Zoning & Subdivision Committee

Thursday, January 14, 2016, 12:30 pm

Staff Report – Britonwood

Logan-Union-Champaign
 regional planning commission
Staff Report – Mitchell Crossing

FINAL PLAT

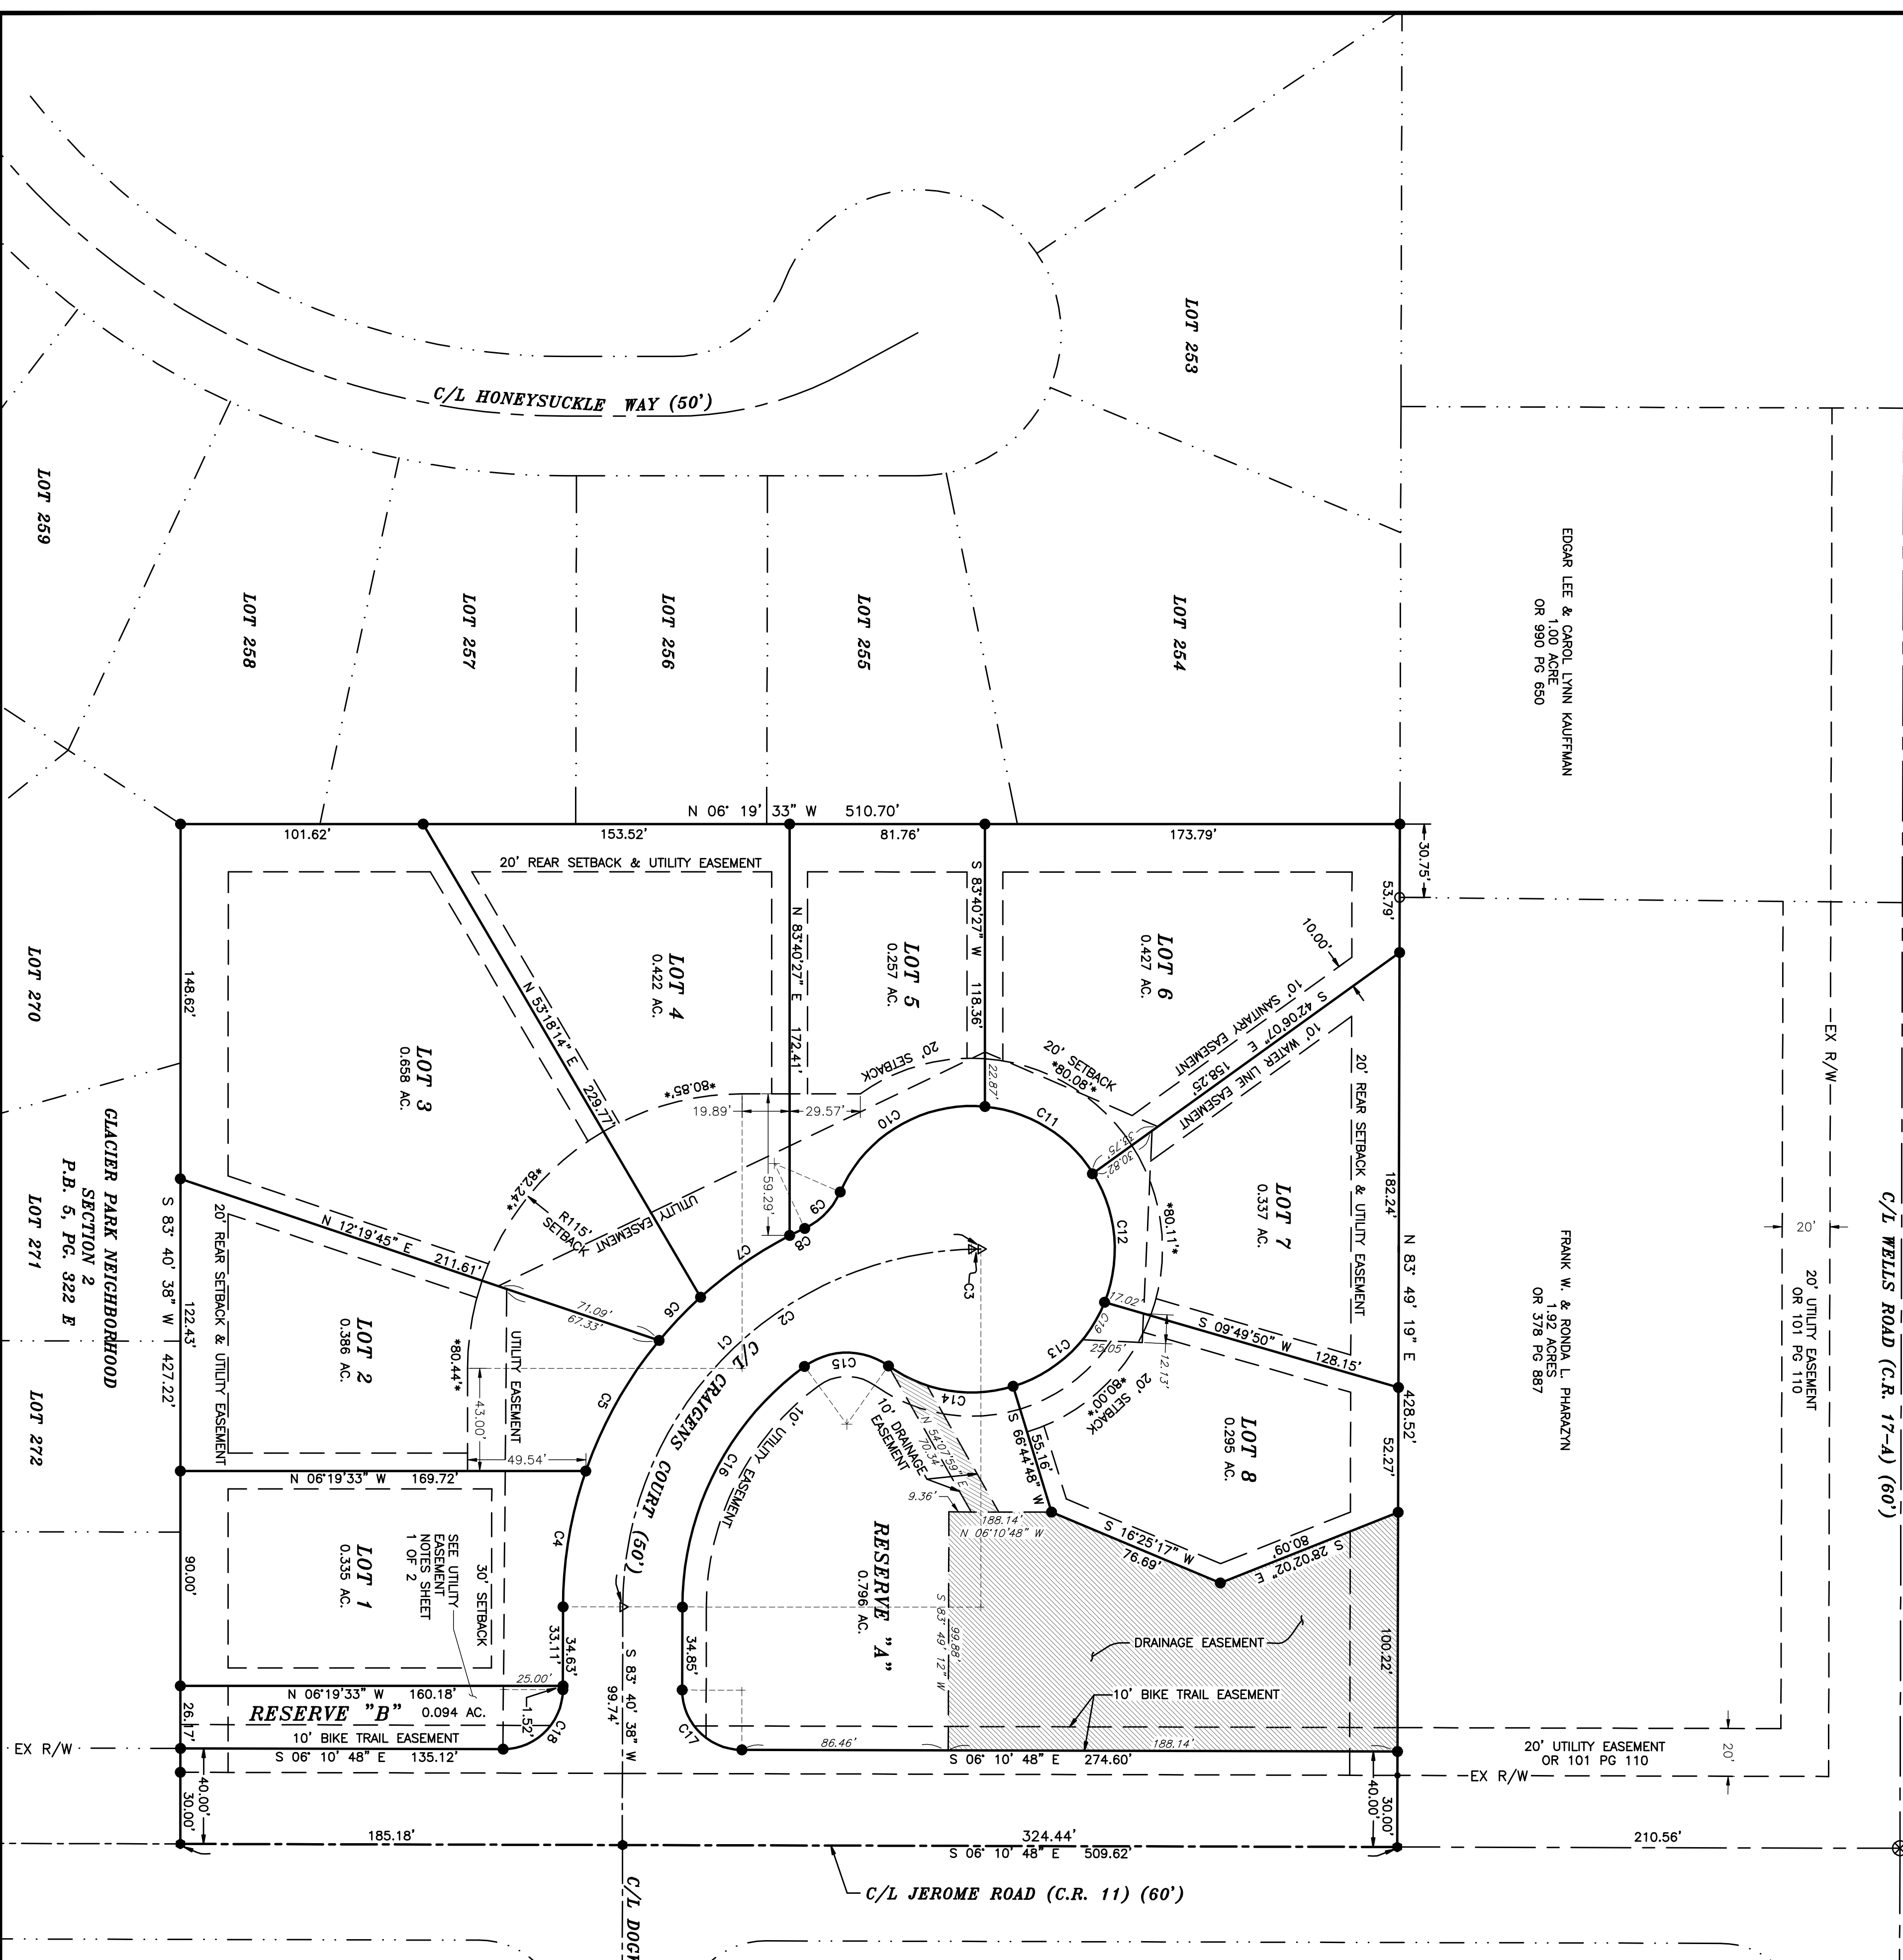
- As the consulting engineer for the Jerome Village Community Authority and owner and operator of the Eversole Run Sewer District, Terrain Evolution submitted comments in a letter dated 09-25-15:
 - ✓ Sheet 1: Clarify that “Sanitary Easement” is covered under the “Utility Easement” language.
 - ✓ Sheet 2: The Utility Easement that extends across Lots 1 and 2 in the front of the lots shall extend to the right of way of Jerome Road across Reserve B.

<p>✓ Sheet 2: The 10 foot Utility Easement along the right of way shall be shown along the frontage of Craigens Court within Reserve A.</p> <ul style="list-style-type: none"> • LUC Regional Planning Commission <ul style="list-style-type: none"> ○ Sheet 1: Under Surveyor’s Certificate, note whether measurements are chord or arc or both (Article 8, pp. 31). ○ Sheet 1: Under Surveyor’s Certificate, note that “monuments shown thereon were or will be placed by the established completion date or prior to the sale of each lot, whichever occurs first (§323, 13.). ○ Easements provided for utility lines shall be least 20 feet in width for sanitary sewers and waterlines. Resolve easement width between lots 6/7 (§414). ○ “A letter from the County Engineer shall be required showing that all required improvements have been either installed and approved by the proper officials or agencies, or that a bond or other surety has been furnished assuring installation of the required improvements” (§324, 2. & 326 & §330).

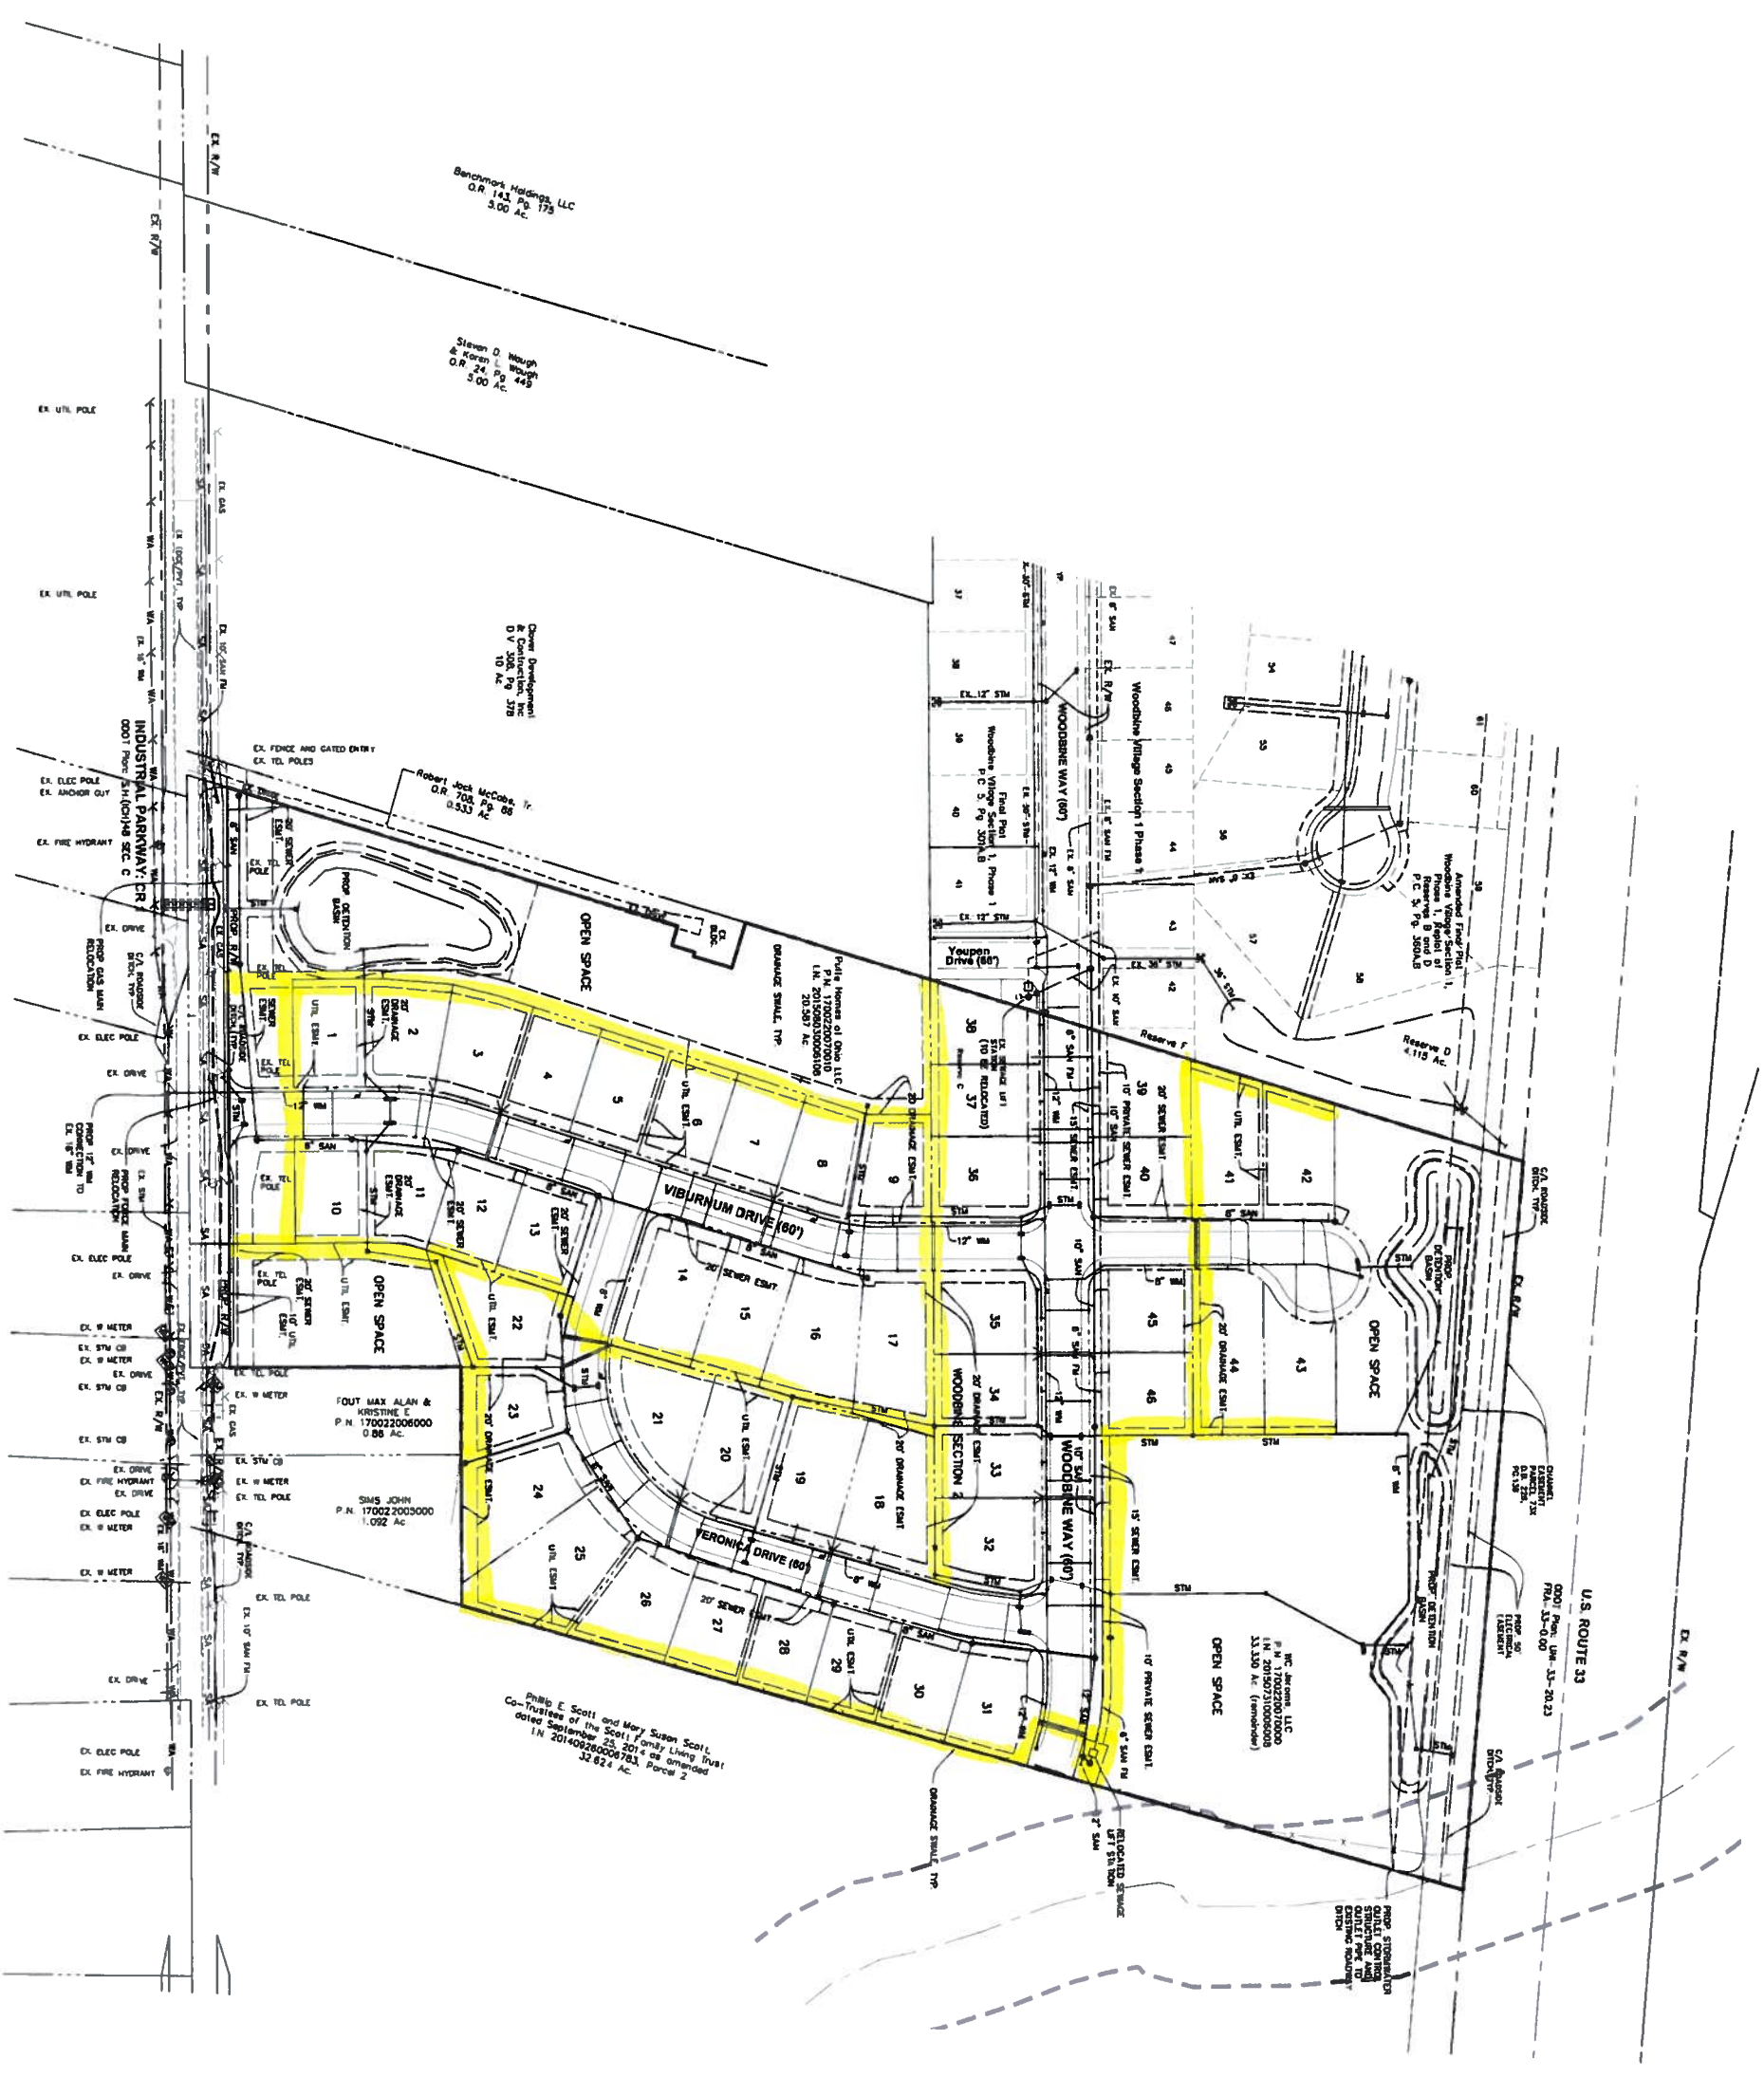
- 1- We have received and commented on several version of this plat in the past. Comments are based on drawing plans dated 12/22/15, numbered 1 – 5.
- 2- URE plans to provide rear lot distribution for properties and will require 20' easements. There are utility easements indicated at the rear of some lots but they are not designated as private utility easements and do not show the size of the easement. Nor are there any written descriptions on the plan regarding private versus public easements. URE needs clarification on the size and location of private utility easements at the rear of all 46 lots. See URE proposed 20 ft. easements noted on edited drawing 4/5.
